Quality Control Check Report. Stage: After Finishing Stage III (Apartments)

Flat No	B-108	Other	-	Sl. No.	41125
Company	MMRK-LUP	Project	GH7	Phase	-
Prepared by	R.S. SAHIBAN	Sign	<i>[Signature]</i>	Date	12-01-2023
Project Manager	A. SURESH	Sign	<i>[Signature]</i>	Date	12-01-2023
Previous stage report no.	40923	MD Sign	Report filed and signed by PM	☒ Yes ☐ No	
Checked By MD on			For filling	☐ Yes ☐ No

Description	Direction	Owners & Developers	Date:	Prepared By:	Approved By:	Scale:	Promoted By:
QC PLUMBING CHECK PLAN	N	Modi Properties Pvt Ltd.	06-02-2021				
		Project Name & Phase Greenwood Heights			Soham Modi	NIS	Modi Properties Pvt. Ltd. Phone +91-04-0033551

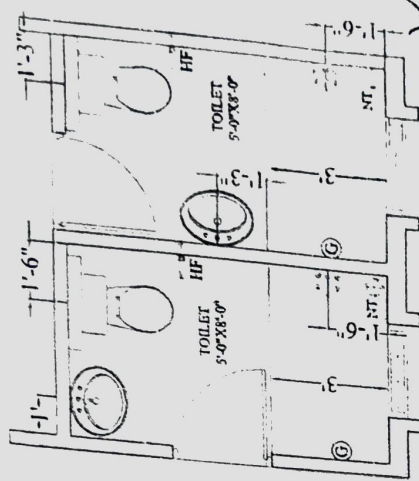
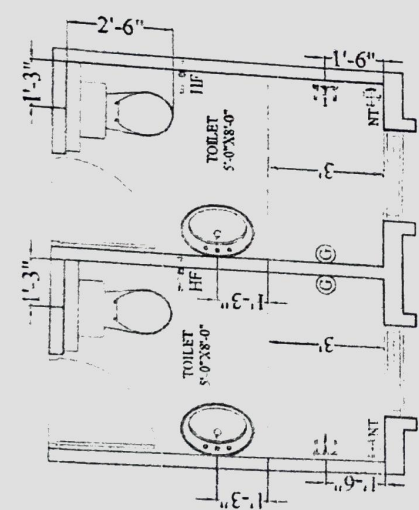
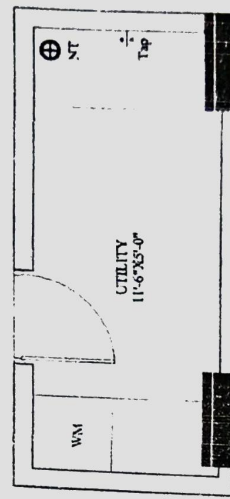
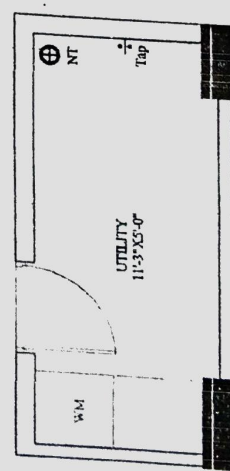
Screeding done on walls upto 12" outside bathroom/utility	☒ Yes	☐ No
Bathroom /utility filled with 4" water for water proof check	☐ Yes	☒ No
Hole packing done around all pipes in ceiling and internal walls	☒ Yes	☐ No
Remarks:		
1) No's parking to be done in Balcony.
